Subject: FCC Class II Permission change for FCC ID: 2AIZN-YY-S-X6858
Original Grant Date: 12/25/2024

This is to request a Class II permission change to our Mobile Phone; Model: X6858, FCC ID: 2AIZN-YY-S-X6858, the device is identical to the previously certified except for the changes as below for details:

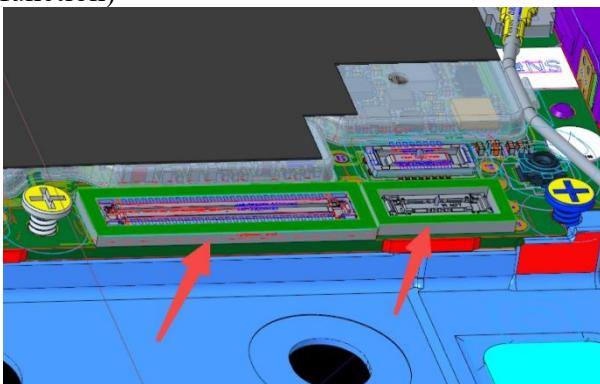
1. WPT Antenna: Enlarged appearance (The FPC is lengthened by 1.8mm, the coil remains unchanged, and the wireless coil charging power is not affected);
2. LED FPC, Reduced appearance (The FPC is shortened by 3.7mm and the width is increased by 1mm. The appearance is changed but the function is not affected.)
